INFORMATION BULLETIN NO. 108

DATE: MAY 2008

**SUBJECT: HAZARD WHEN TRAMMING FLETCHER MACHINES WITH INDEPENDENT LEFT AND RIGHT TRAM LEVERS
REPLACEMENT OF TRAM CONTROL VALVE REQUIRED**

DATE CODE STAMPED ON PLATE

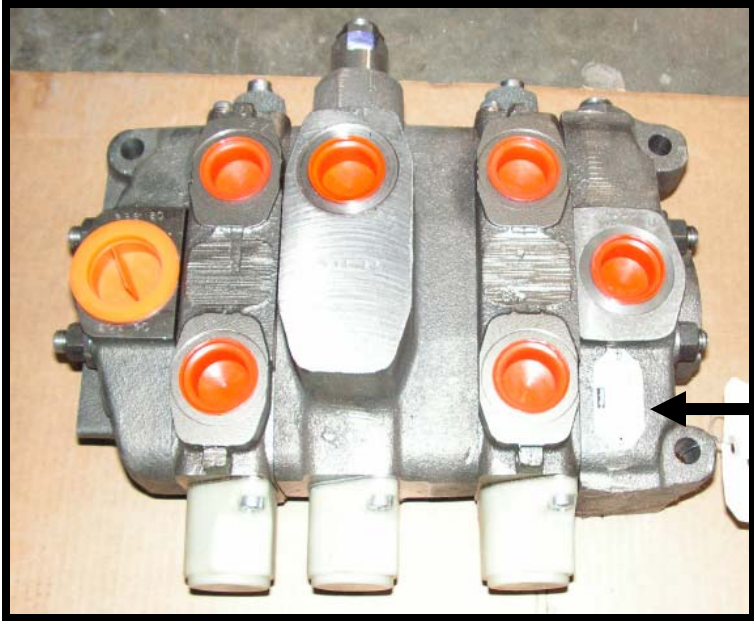
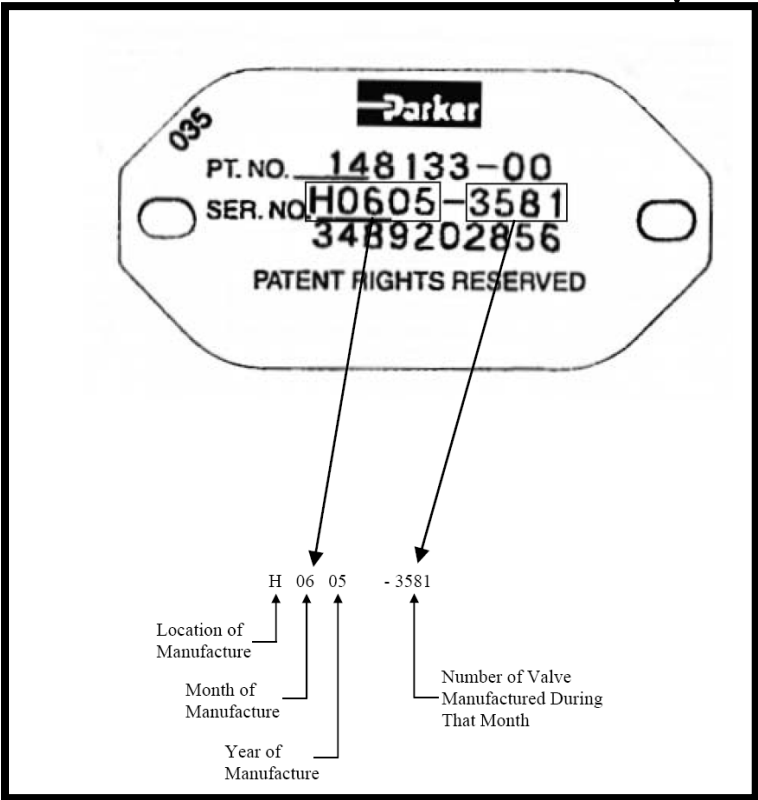
2. If you received a tram valve through Fletcher's Service Department or one of our distributors, check the date code on the tram valve (see attached photo showing where the date code can be found). If the date code is between May 2005 and July 2007 contact the Risk Management Department and we will schedule a field representative to come to your mine and change out the valve.
